Mt Olive Creek Solar, LLC  
Response to Siting Board's Initial Request for Information  
Case No. 2020-00226

Request No 1: Refer to the Application, Attachment I, pages 1 and 4.

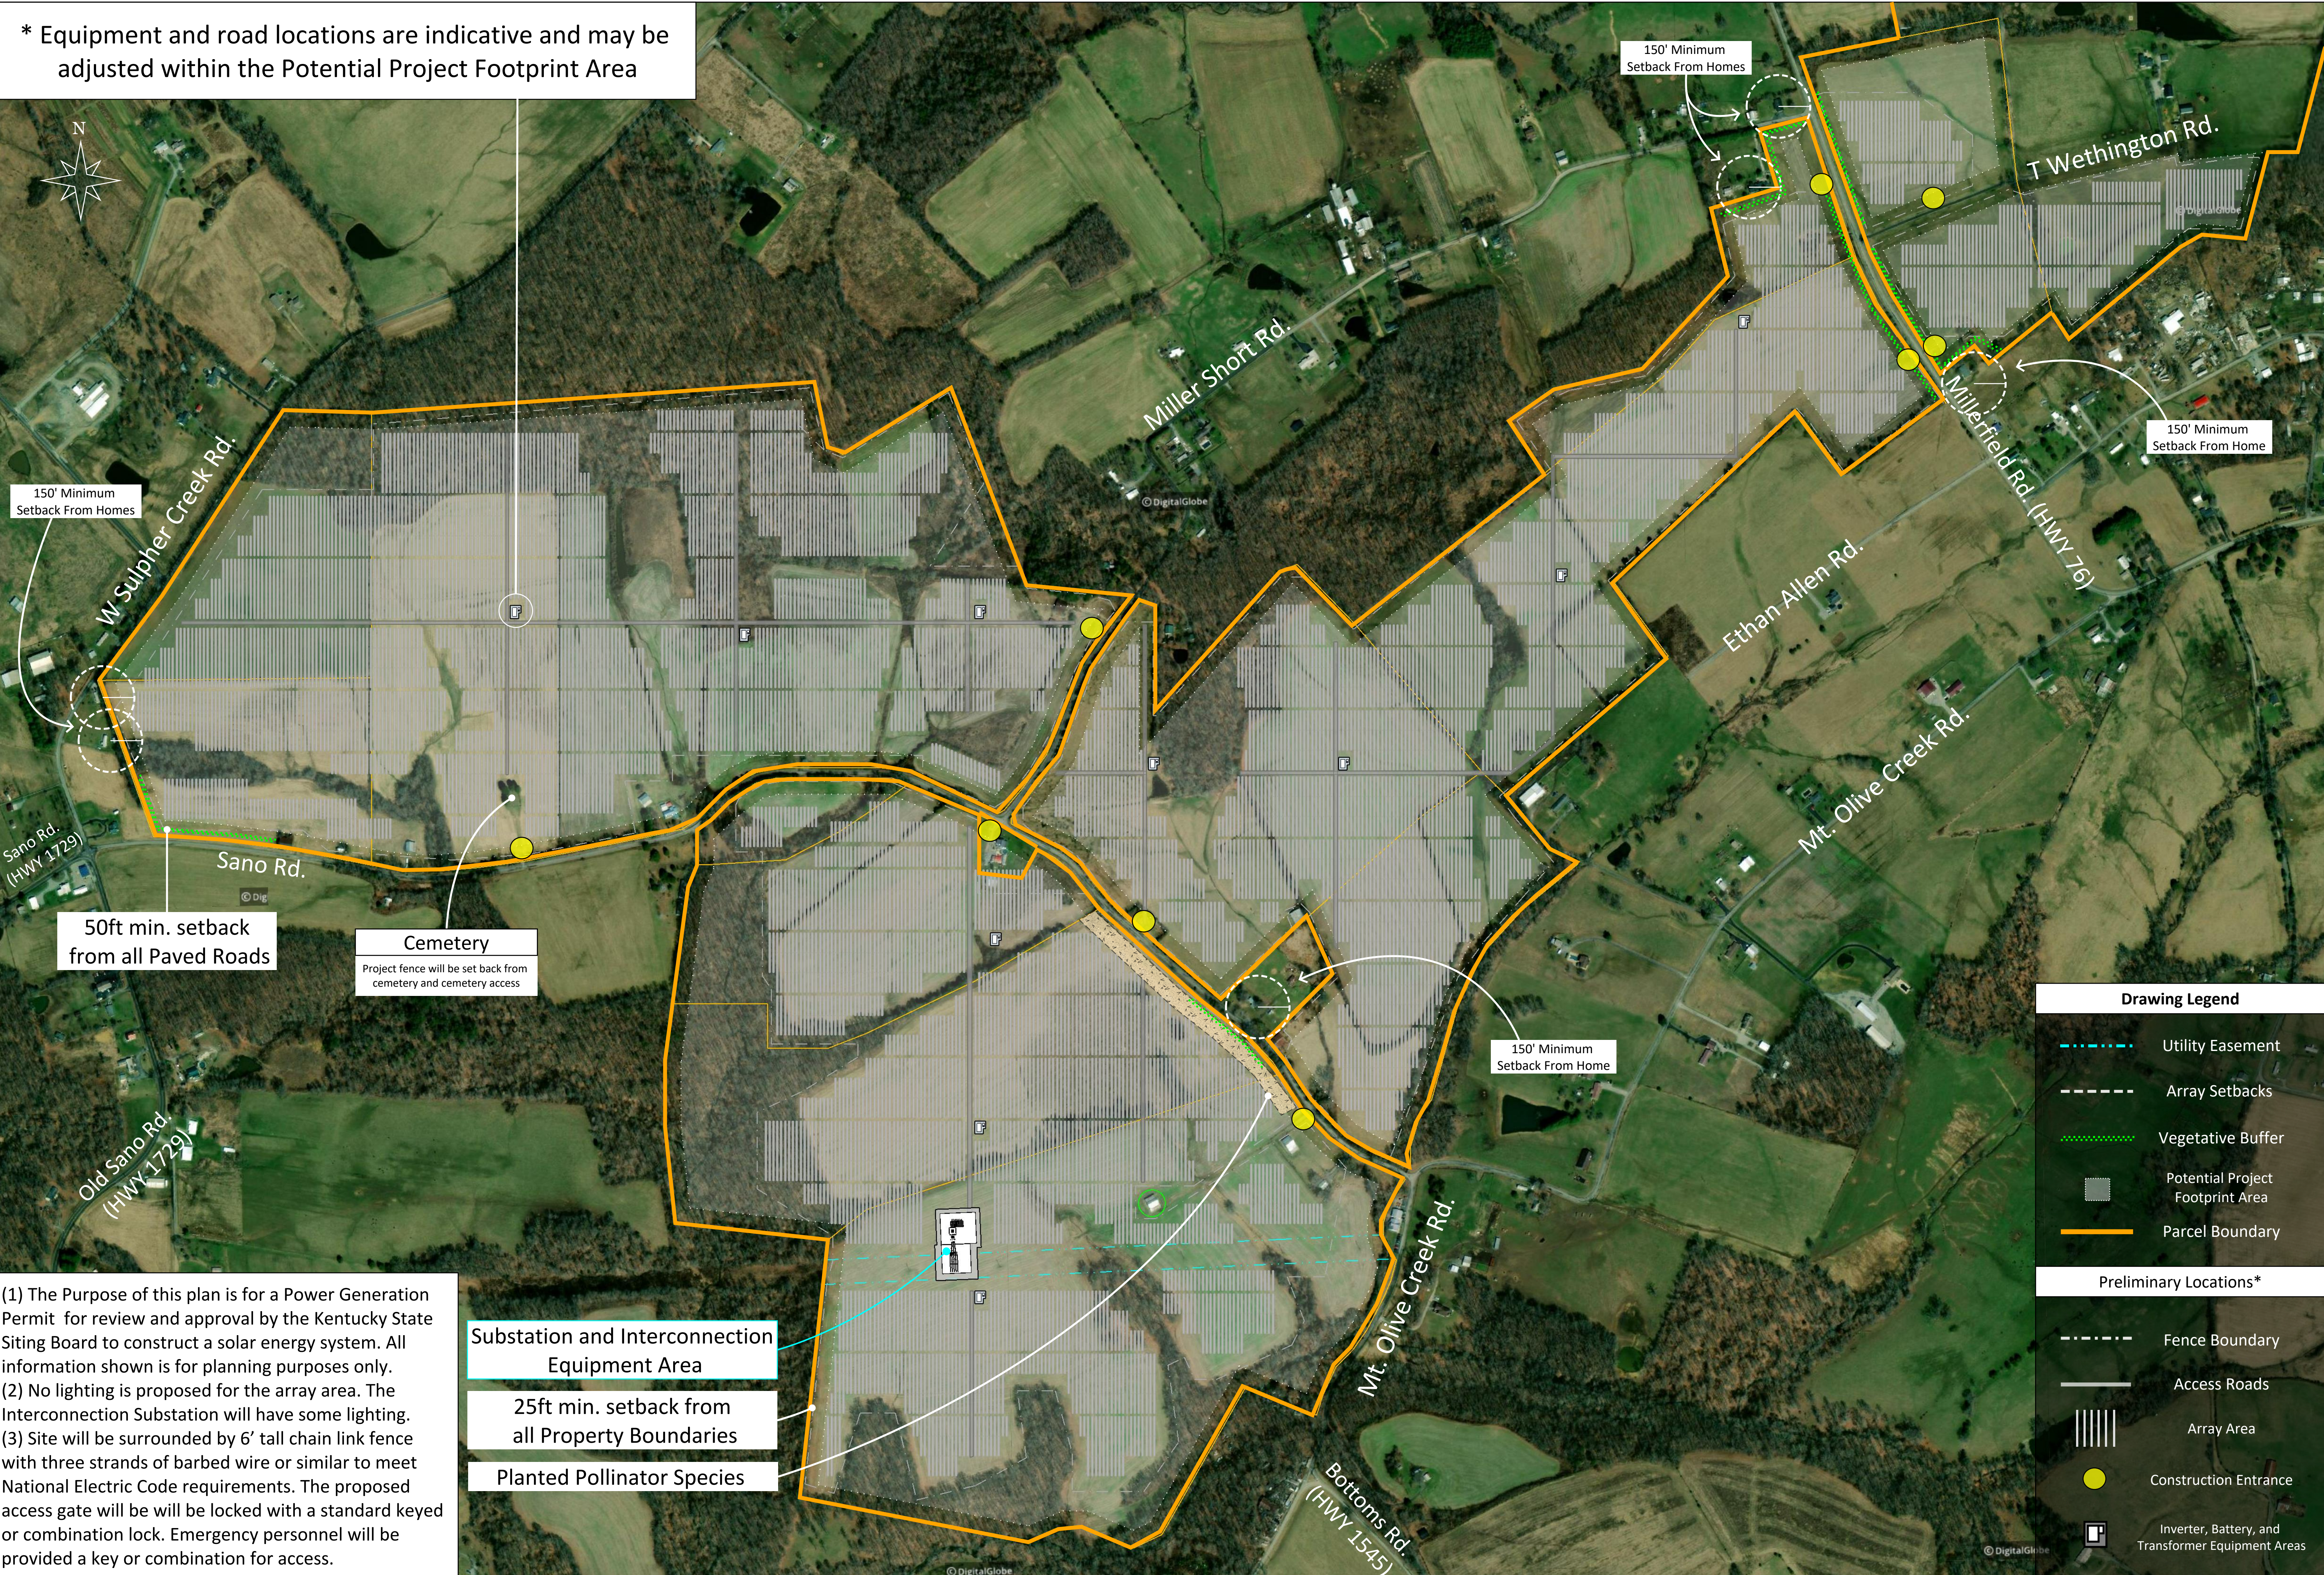
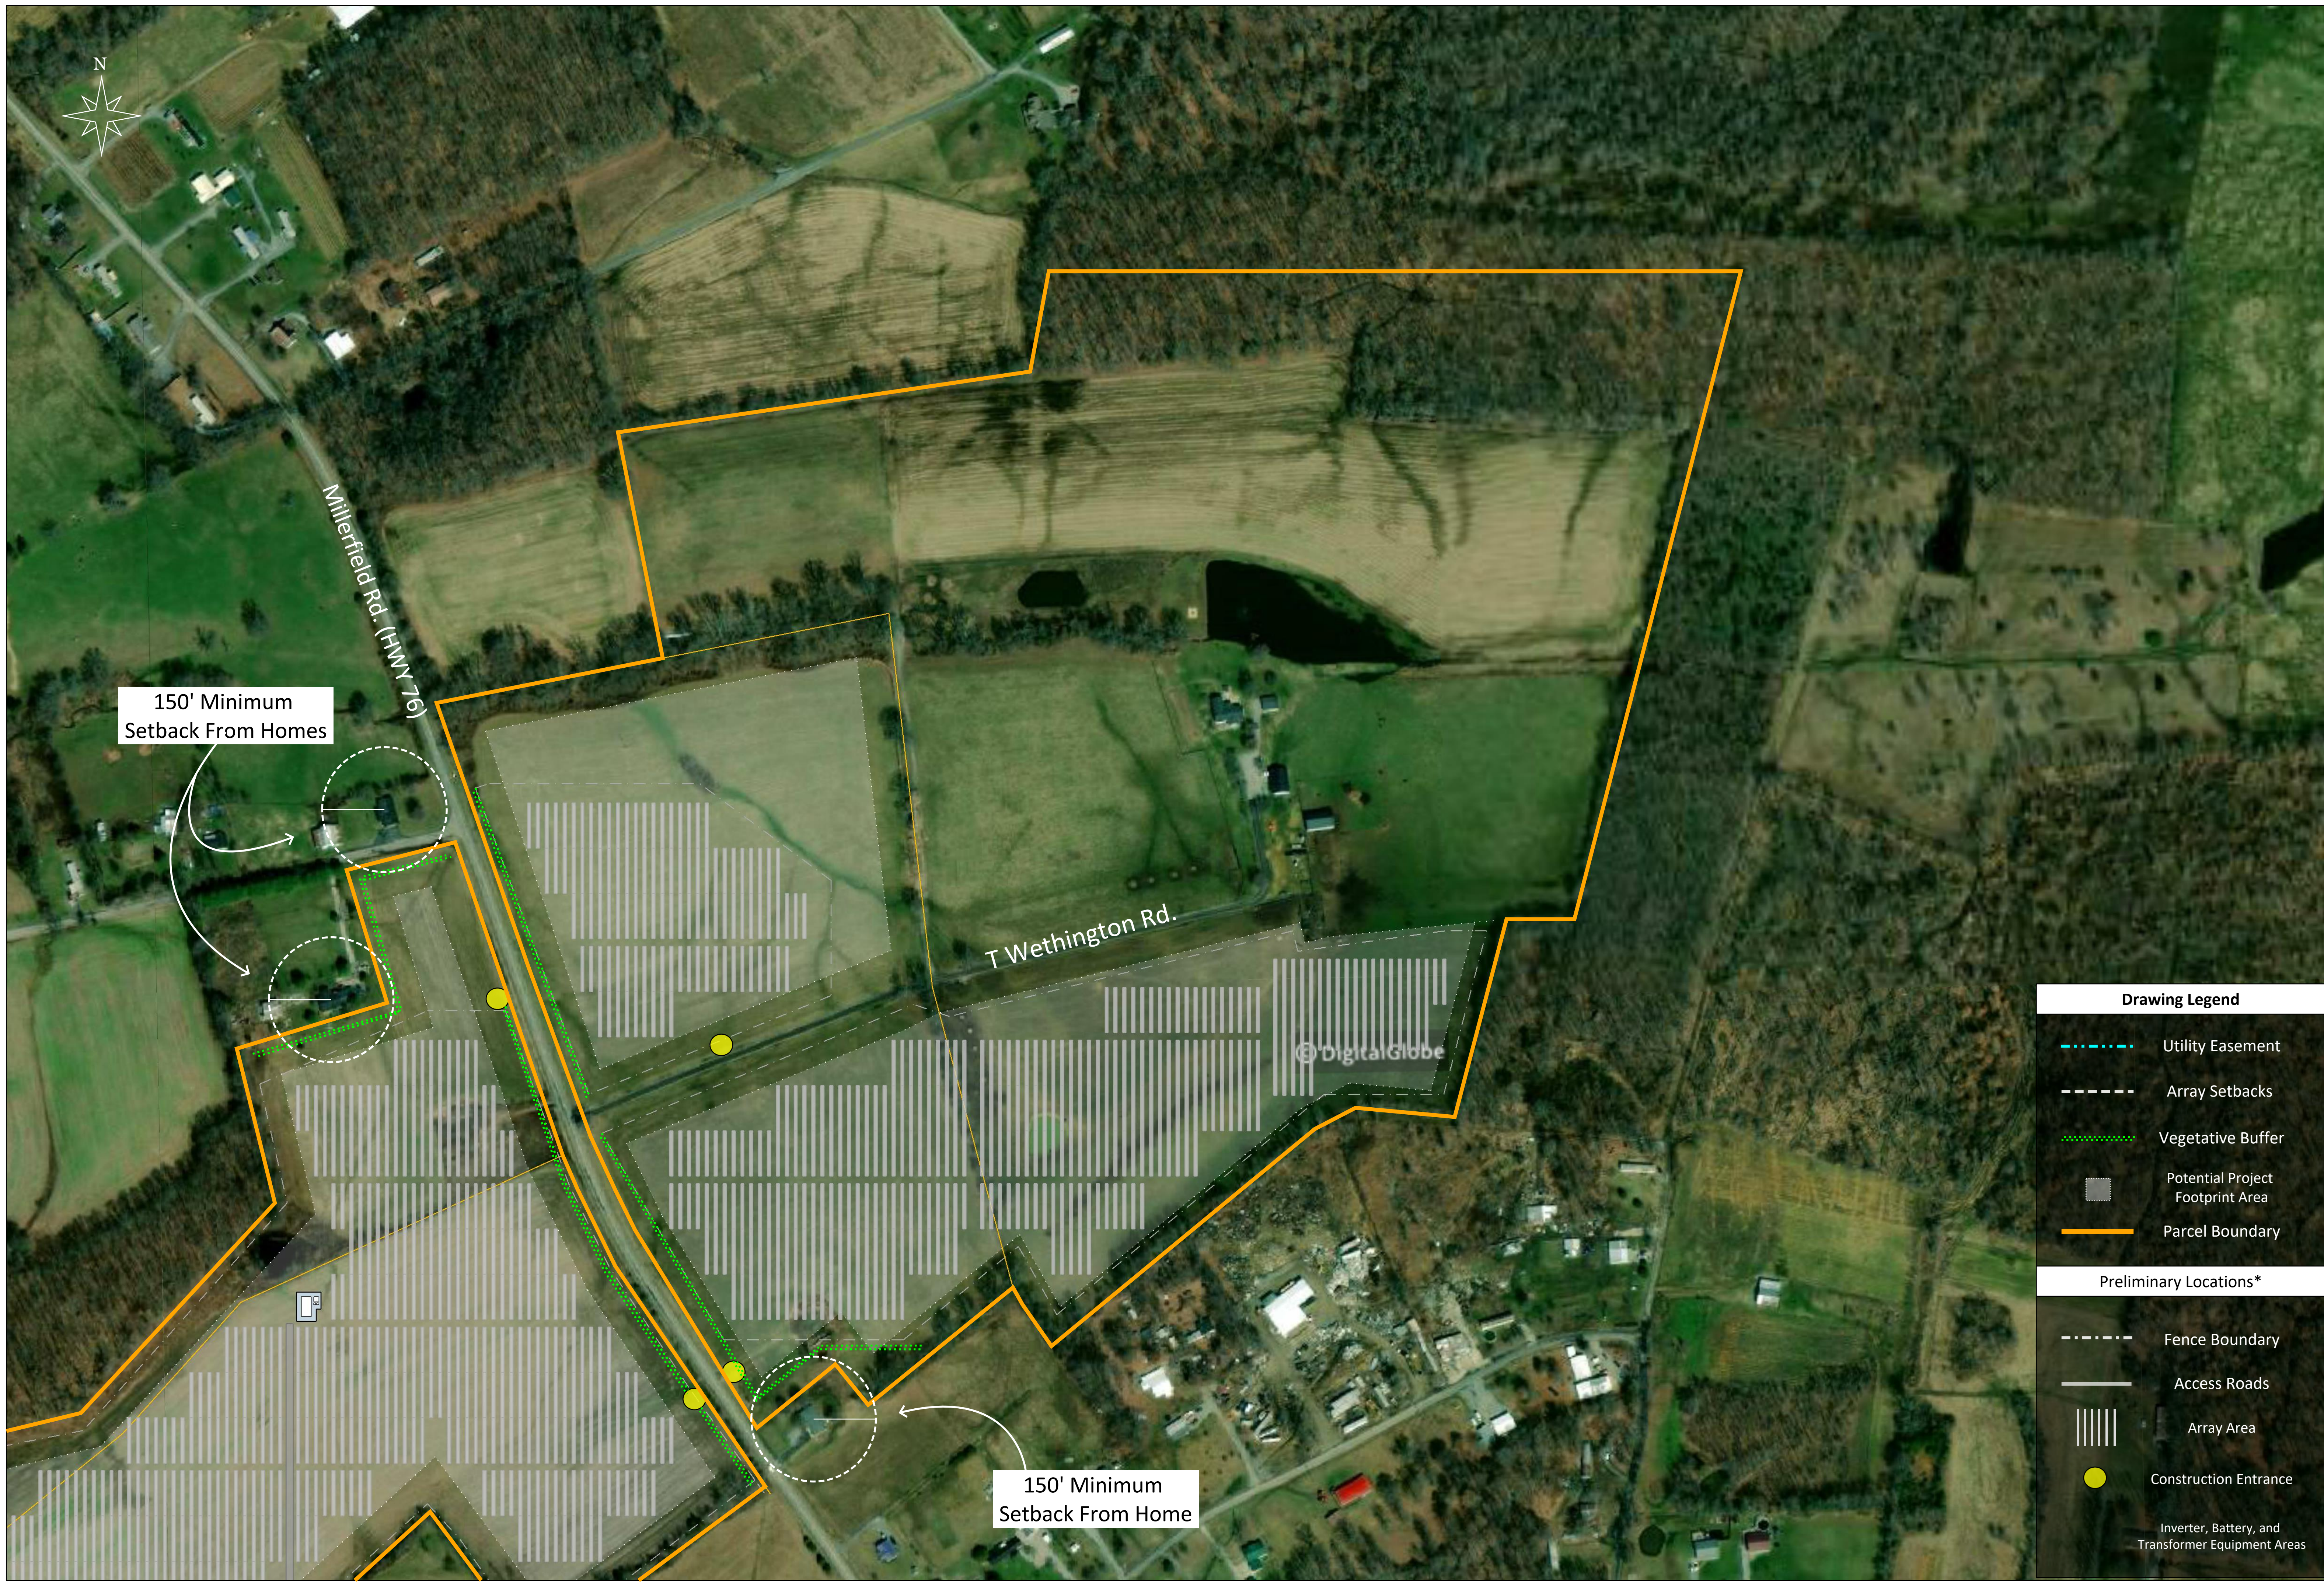
Request No 15: Refer to the Site Assessment Report, Attachment A, Preliminary Project Layout, which shows the property boundary extending beyond the border of the map. Provide a new map to accompany the Preliminary Project Layout that includes the T. Wethington Road area. Include the same layers and legend in this map.

1. SAR Attachment A – Preliminary Project Layout (map)--The Parcel Boundary line is unclear for the northeastern most portion of the property (east of Millerfield Road). Please revise the map to show the full Project boundary enclosed in the thick orange line.
2. The Project Outline included on the Mt Olive Solar Context Map (Attachment A of the Application) (incorrectly referred to as the Horseshoe Benjamin Lindermeierd Solar Project Outline) does not appear to include the entire Project site in the northeast corner. The outline on this map is not consistent with the Preliminary Project Layout Map (Attachment A of the SAR), the Tax Parcel Map included in the Property Value Impacts Report (Attachment B of the SAR), or the Boundary Survey (Attachment E of the SAR). Please explain the difference, or revise.

Response: See Below.

1. See response to request # 15.
2. See response to request # 16. The proposed project footprint does not match the tax parcel map or the boundary survey as the project is leasing partial parcels and not always occupying full legal lots.
